Access Compliance Report

Public Rights-of-Way

(Curb Ramps)

Intersection ID: 49133	Main Street: EWERT CUT LN	Cross Street: AMBER LEIGH WAY DR	Location: NE
ADA ID: 3486A0CB41C3	Ramp Type: Perp	Initial Pass/Fail: Fail	Overall Compliance: No
Severity Score: 10			
Codes/Mitigation Info/Possible Solution		Field Measurements/Component Compliance

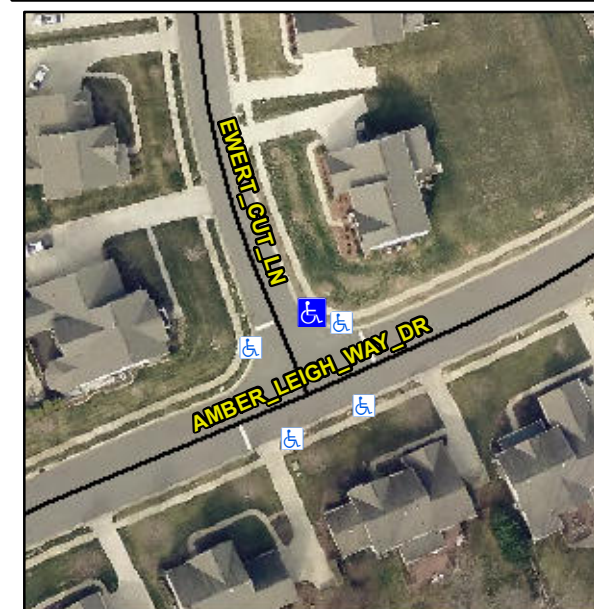
Not Found, R304.5.1, R304.5.3

Compliance	Description	Data	Compliance	Description	Data
N/A	Ramp Length (in)	48.5	Yes	Ramp Slope (%)	6.8
No	Ramp Width (in)	47.0	No	Ramp XSlope (%)	3.5
N/A	Flare Type LT	N/A	N/A	Flare Type RT	N/A
N/A	Flare Slope LT (%)	N/A	N/A	Flare Slope RT (%)	N/A
N/A	Flare Traversable LT?	N/A	N/A	Flare Traversable RT?	N/A
N/A	Landing Length (in)	N/A	N/A	DWS Provided?	N/A
N/A	Landing Width (in)	N/A	N/A	DWS Contrast?	N/A
N/A	Landing Slope (%)	N/A	N/A	DWS Length (in)	N/A
N/A	Landing X Slope (%)	N/A	N/A	DWS Full Width?	N/A
N/A	Landing Curb? (Y/N)	N/A	N/A	DWS Offset (in)	N/A
N/A	Shared Landing?	N/A			
N/A	Gutter Ponding?	N/A	N/A	Gutter Slope (%)	N/A
N/A	Gutter Lip Ht (in)	N/A	N/A	Gutter X Slope (%)	N/A
N/A	Painted X Walk1?	No	N/A	Painted X Walk2?	N/A
	X Walk 1 Direction	To W		X Walk 2 Direction	N/A
N/A	X Walk 1 Width (in)	N/A	N/A	X Walk 2 Width (in)	N/A
	X Walk 1 Slope (%)	0.3		X Walk 2 Slope (%)	N/A
	X Walk 1 X Slope (%)	2.5		X Walk 2 X Slope (%)	N/A

Remove & Replace Entire Ramp.
